Access Compliance Report Public Rights-of-Way (Curb Ramps)

Main Street: CHANTICLEER_RD Cross Street: ANTIGUA_ST Location: NW

ADA ID: RPRK210923142753 Ramp Type: Type 1 - Perpendicular Diagonal Initial Pass/Fail: Fail Overall Compliance: No Severity Score: 32

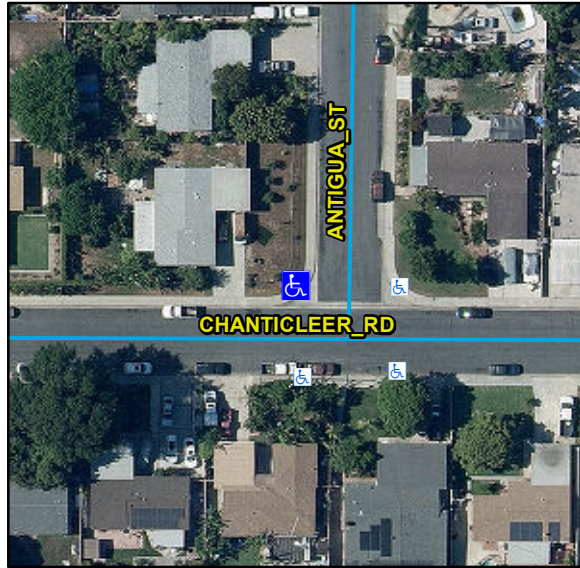
Remove & Replace Curb Ramp With Two New Directional Ramps or Equivalent. Grind Gutter Lip.

R204.3, R304.2.2, R304.5.3, R302.7.2, STD 1115
